**SUNDRY NOTICES AND REPORTS ON WELLS**  
***Do not use this form for proposals to drill or to re-enter an abandoned well. Use Form 3160-3 (APD) for such proposals.***

| 1. Type of Well<br><input checked="" type="checkbox"/> Oil Well <input type="checkbox"/> Gas Well <input type="checkbox"/> Other | 8. Well Name and No. <b>JUPITER 30 FED COM/705H</b>        |   |

Jupiter 30 Fed Com 705H API #: 30-025-52716

EOG respectfully requests an amendment to our approved APD for this well to reflect the following changes:

Revised Wellbore

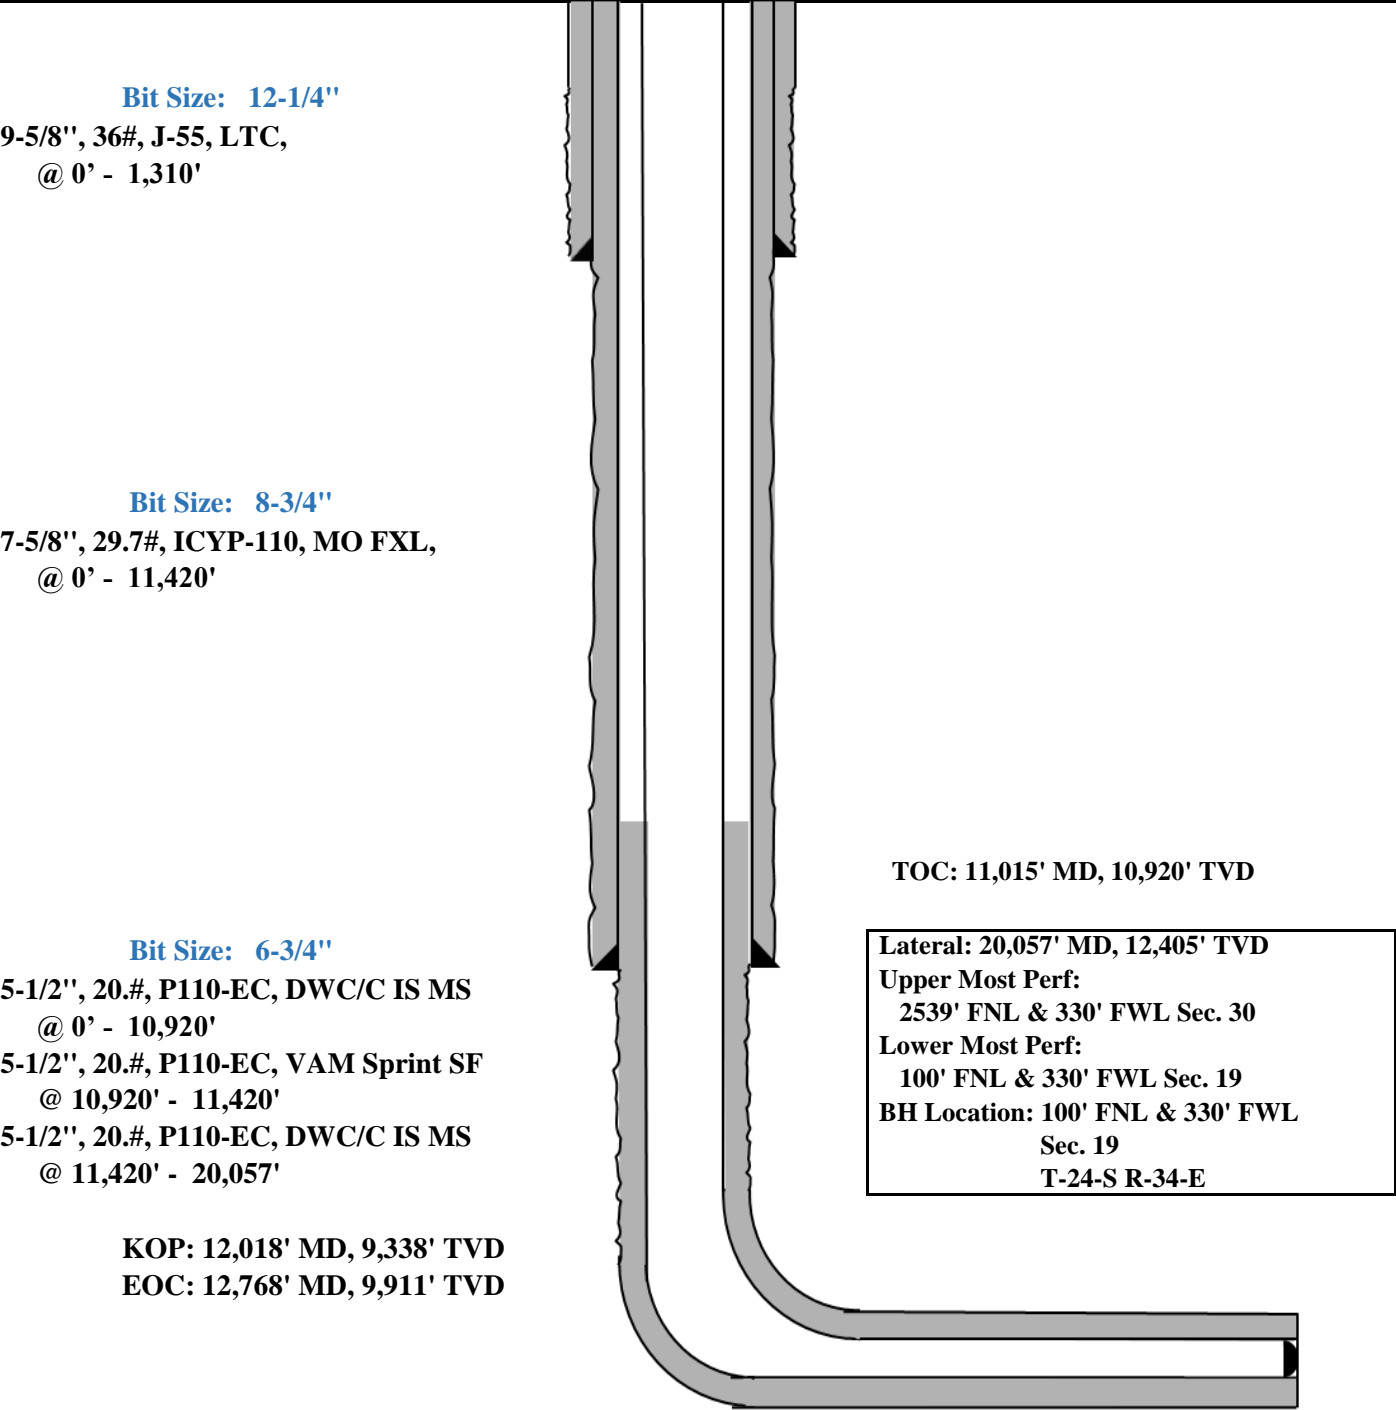
Change SHL from T-24-S, R-34-E, Sec 30, 2073' FNL, 1946' FWL, Lea Co., NM,  
to T-24-S, R-34-E, Sec 30, 2133' FNL, 1239' FWL, Lea Co., N.M.

Change BHL from T-24-S, R-34-E, Sec 19, 100' FNL, 1650' FWL, Lea Co., NM,  
to T-24-S, R-34-E, Sec 19, 100' FNL, 330' FWL, Lea Co., N.M.

Update casing and cement program to current design.
